I-2513 B & D

I-2513 B & D 4B Meeting Minutes

I-2513B&D Concurrence Point 4B Meeting

PROJECT REFERENCE NO.		SHEET NO.
1-2513B&D		
ROADWAY DESIGN ENGINEER	HYDRAULICS ENGINEER	
DOCUMENT NOT CONSIDERED FINAL UNLESS ALL SIGNATURES COMPLETED		
PERMIT DRAWING SHEET 32 OF 85

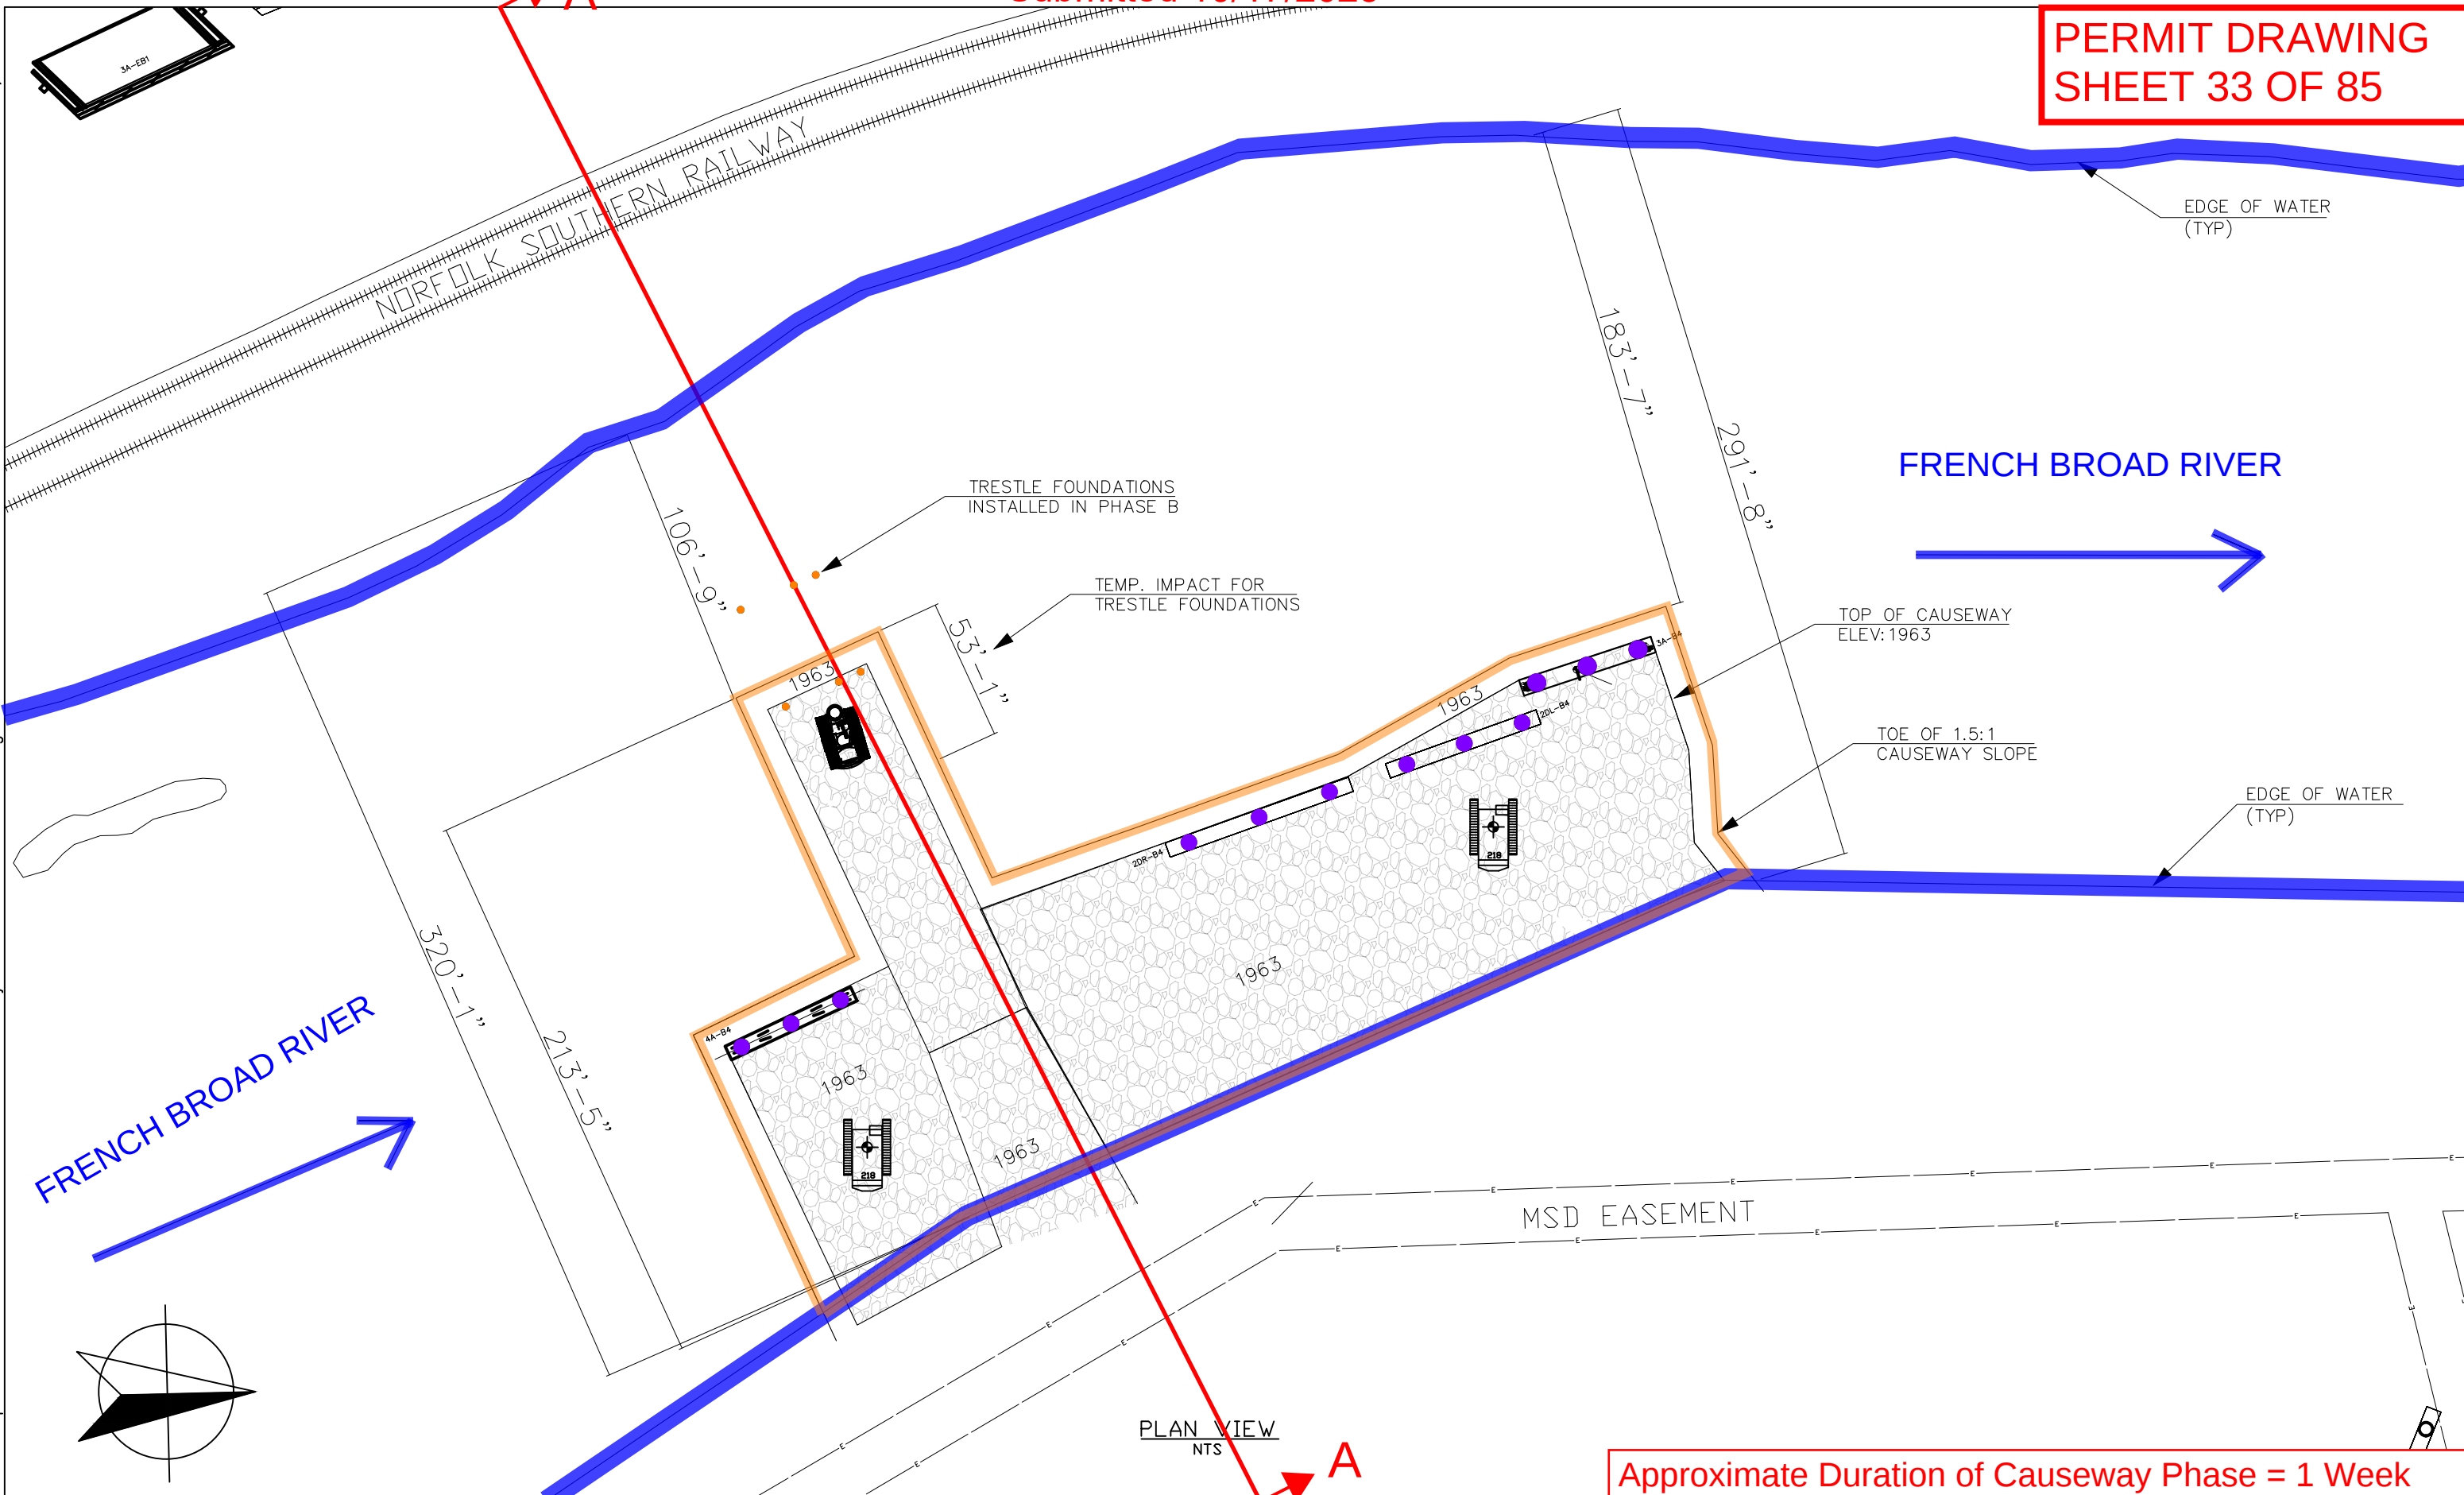
-Causeway Phase 1A - PDF ps. 35 and 36, Permit Drawing Sheets 30 and 31 - showing 14.1% of river flow open. Is this a "short duration" restriction that will be coordinated further with FWS and COE? How long is it expected to be in place? And similar concerns to what Dave proposed re. anticipated hydraulic conditions.

16. For **Causeway Phase 1A** (PDF pages 35–36, Permit Drawing Sheets 30–31), which shows 14.1% of river flow open:
